**Economic and Social Council**Distr.: General
7 August 2019

Economic Commission for Europe**Inland Transport Committee****World Forum for Harmonization of Vehicle Regulations****Working Party on Lighting and Light-Signalling****Eighty-second session**

UN Regulation No. 48 (Installation of lighting and light-signalling devices):**Proposals for new series of amendments to UN Regulation No. 48****Proposal for a new 08 series of amendments to UN
Regulation No. 48 (Installation of lighting and light-signalling
devices)****Submitted by the expert from the Special Interest Group***

Model A

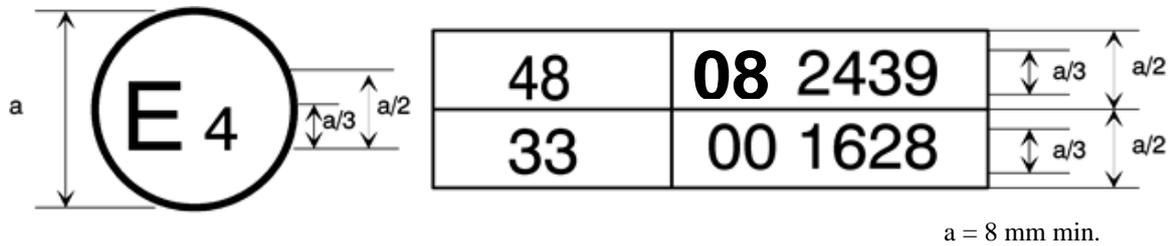
The above approval mark affixed to a vehicle shows that the vehicle type concerned has, with regard to the installation of lighting and light-signalling devices, been approved in the Netherlands (E4) pursuant to UN Regulation No. 48 as amended by the 08 series of amendments. The approval number indicates that the approval was granted in accordance with the requirements of UN Regulation No. 48 as amended by the 08 series of amendments.
